TSG-RAN Working Group 1 meeting #9　　　　　　　**TSGR1#9(99)k29**
Dresden, Germany
November 30 – December 3, 1999

Title:　　　　　CR 25.215-014r01, 015r01:
　　　　　　　　　Range and resolution of BER/BLER measurements

CHANGE REQUEST

25.215 CR **014r01** Current Version: 3.0.0

Figure 1　Mapping of physical channel BER

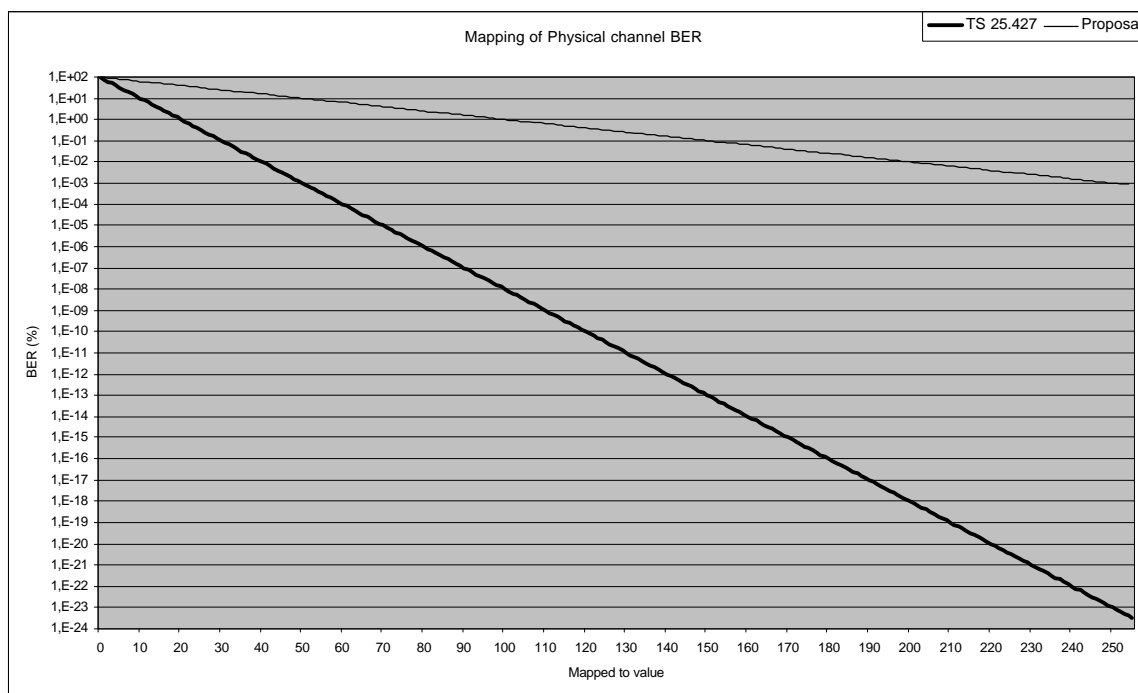
The range proposed in 25.427 goes down to BER values as low as $3.2*10^{-26}$ (QE=25.5). That seems to be somewhat low and the actual interesting area for the BER is somewhere between 0,1 to 10%. Representing values down to 10^{-26} will also imply that the resolution in the BER interval of interest will be worse than if a smaller range is choosen, using the same number of bits. In figure 1 below the mapping defined in 25.427 is shown together with a proposal for a new mapping (both using 8 bits = 256 values).

Mapping of the Physical channel BER in the proposal:

BER_dB%=-Log10(Physical channel BER), with value range [0 - 5.08] in step of 0.02 for Physical channel BER>0
BER_dB%=5.10 for Physical channel BER=0.

This mapping makes it possible to represent BER down to approx. 10^{-5}. Consider a worst case where the uplink channel bit rate is 960kbps (SF=4). The maximum TTI is 80ms, which leads that the maximum number of bits received during 80ms will be 960kbps x 80ms = 76800. To resolve one erroneous bit a resolution of 1/76800 = $1.3*10^{-5}$ is required. The lowest resolvable BER (except BER=0) in the proposal is $10^{-5.08} = 0.83*10^{-5}$ which will be sufficient.

**Figure 2   Quantisation step size for the mapping in TS 25.427**

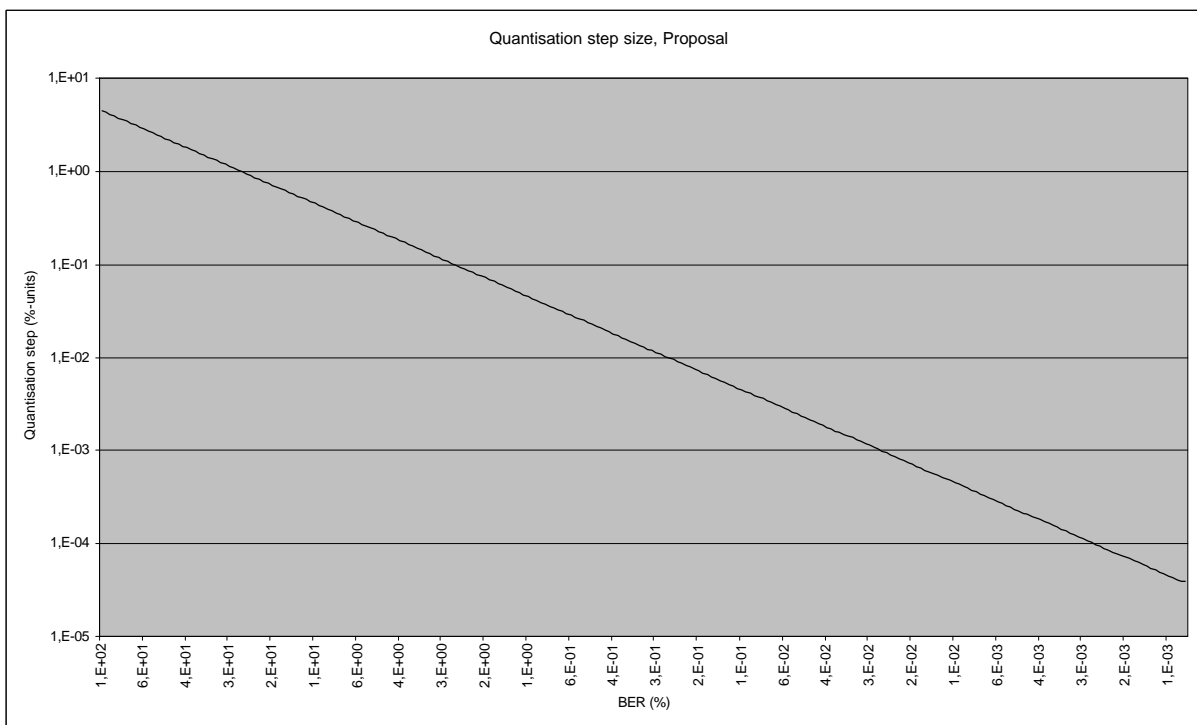
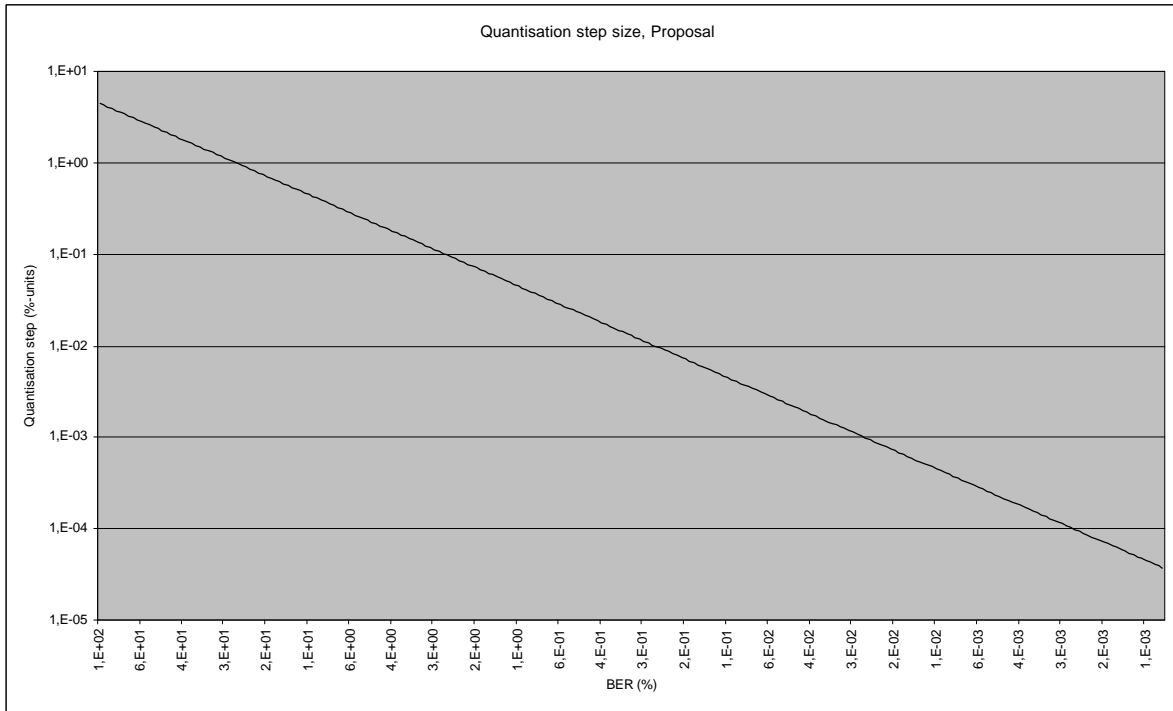
In figure 2 and 3 below the quantisation step size for the current mapping in TS 25.427 and the proposed mapping of physical channel BER is shown.

In the table below the quantisation step is shown around BER 0,1%, 1% and 10%
